Company	Trenz Electronic GmbH
PCN Number	PCN-20210612
Title	TE0782-02 eMMC Change
Subject	BOM change
Issue Date	2021-08-18

2.1 #1 Change eMMC (U5) from IS21ES08G-JCLI to SDINBDG4-8G-XI2

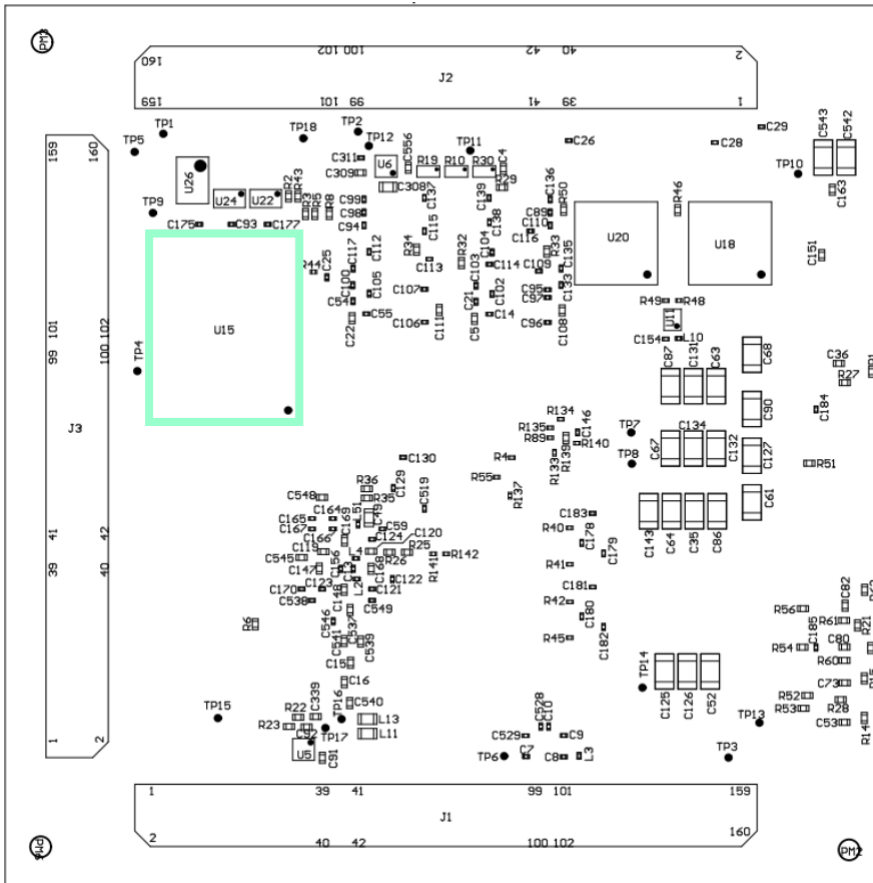
Type: BOM change

Reason: Distributor informed about unforeseeable immediate EOL of parts. No official documents from manufacturer are available. No LTB, already confirmed orders were cancelled by distributor/manufacturer.

Locate eMMC (U15) on PCB:

old	new
IS21ES08G-JCLI	SDINBDG4-8G-XI2

Impact: None. Replacement has same capacity as used on corresponding affected variant. Reference designs for vivado versions 2019.2 and 2020.2 were tested and work properly without any changes.
